ADA IMPROVEMENTS – PHASE 1

**KILLINGLY MEMORIAL SCHOOL
339 MAIN STREET
DANIELSON, CT 06239
STATE PROJECT NO. 069-0068 CV**

DATE: October 30, 2018

The following changes to the Drawings and Project Specifications shall become a part of the Drawings and Project Specifications; superseding previously issued Drawings and Project Specifications to the extent modified by Addendum No. 3.

PINNED CONCRETE SIDEWALK DET. A
SCALE: 1" = 1'-0"

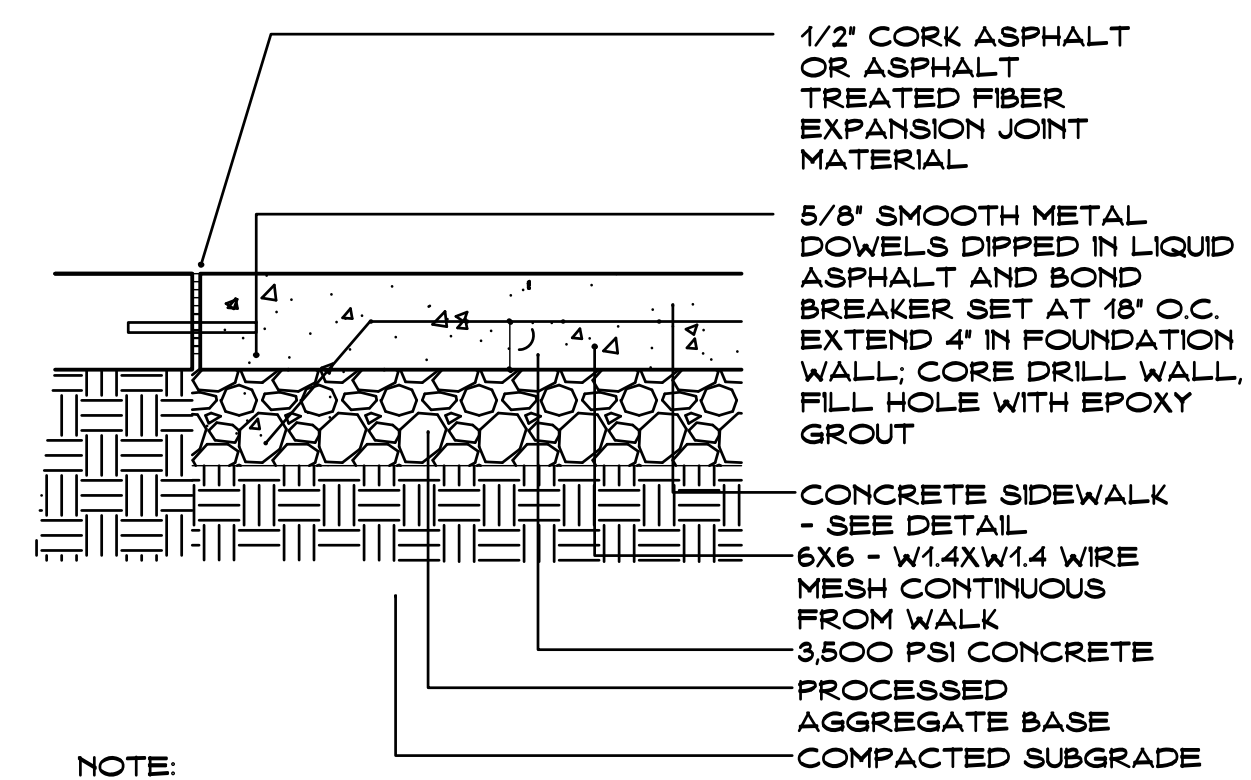
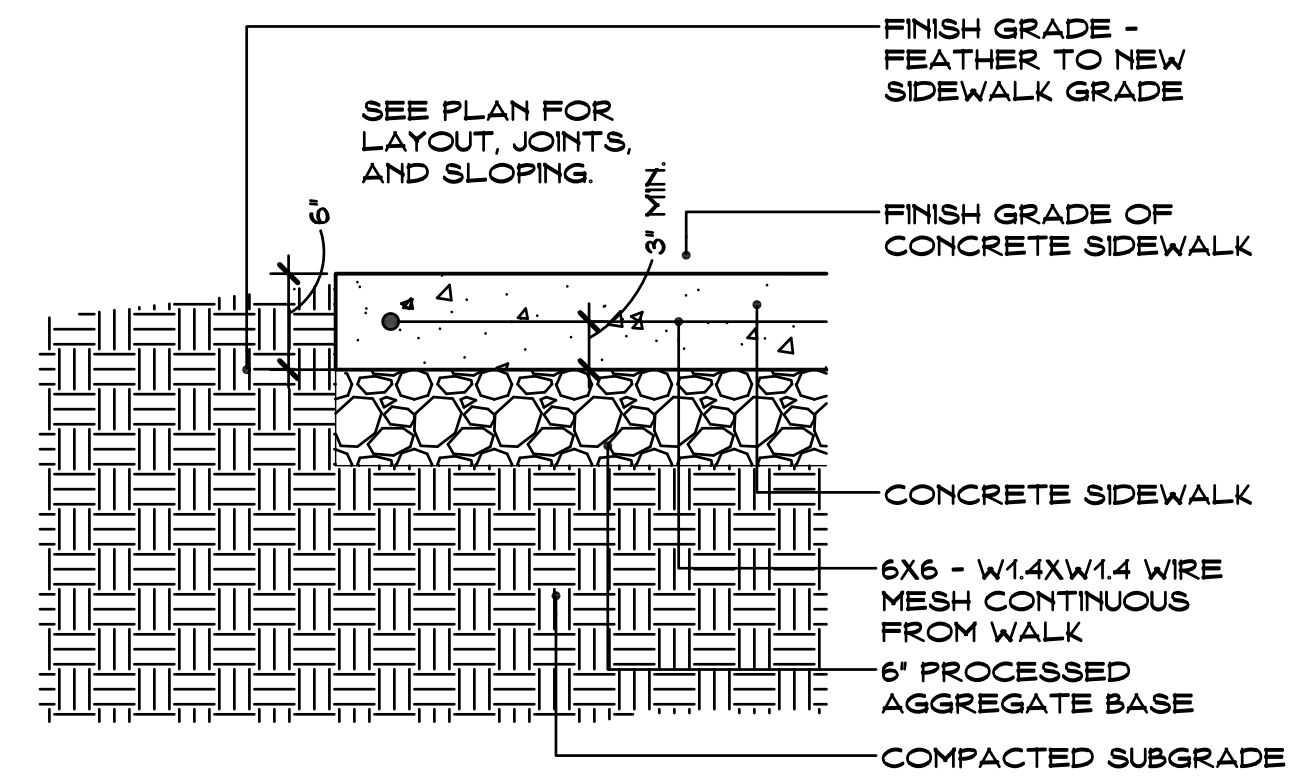
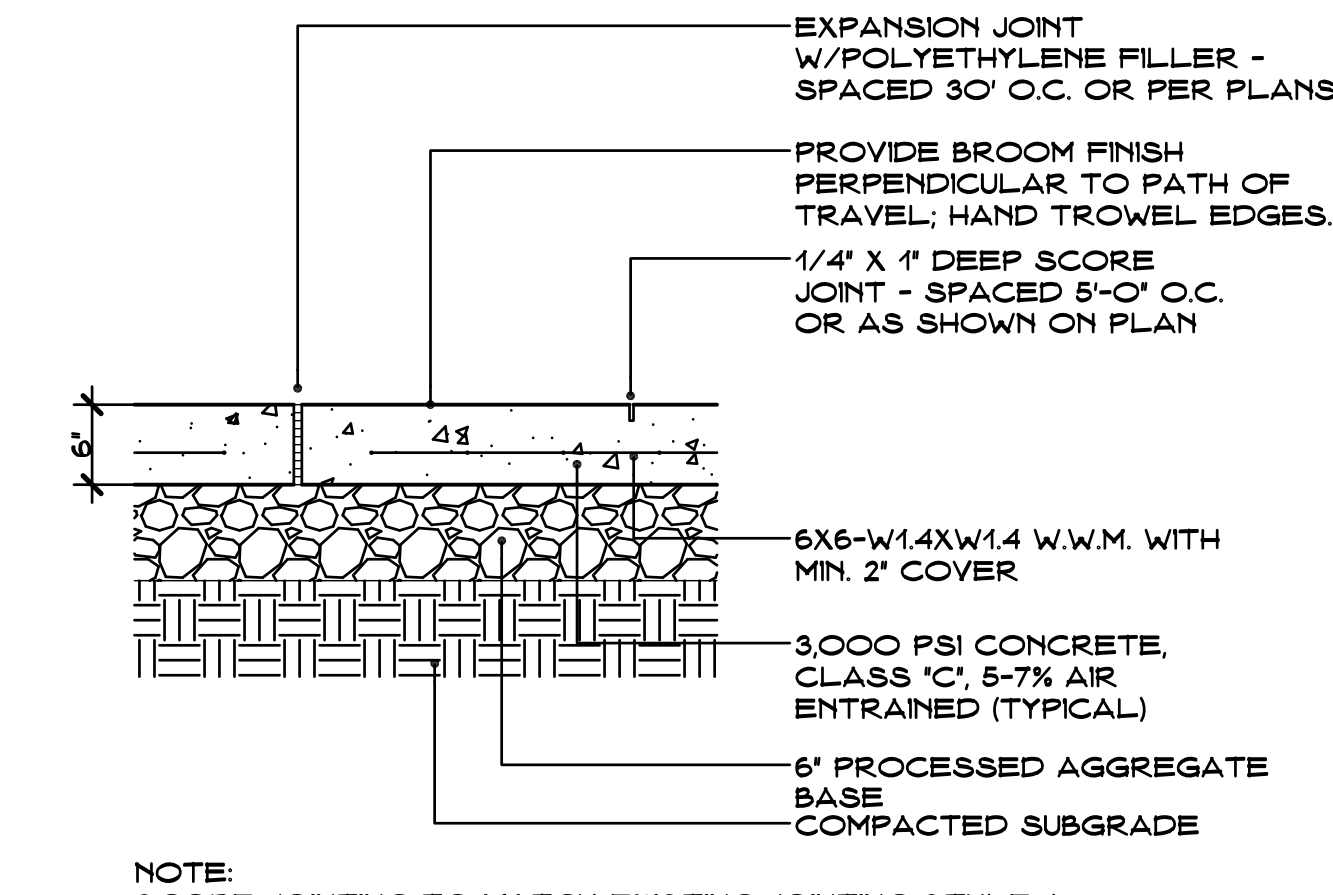
At the pre-bid meeting at Killingly Memorial school, it was mentioned that there is some sidewalk replacement at one of the entrances. This is not depicted on the plans. Please provide details and the extent of the sidewalk replacement.

There is minor site work outside of Vestibule E27 that consists of replacing a concrete sidewalk and associated grading.

There is minor work outside of Vestibule E27 that consists of replacing a concrete sidewalk and associated grading.
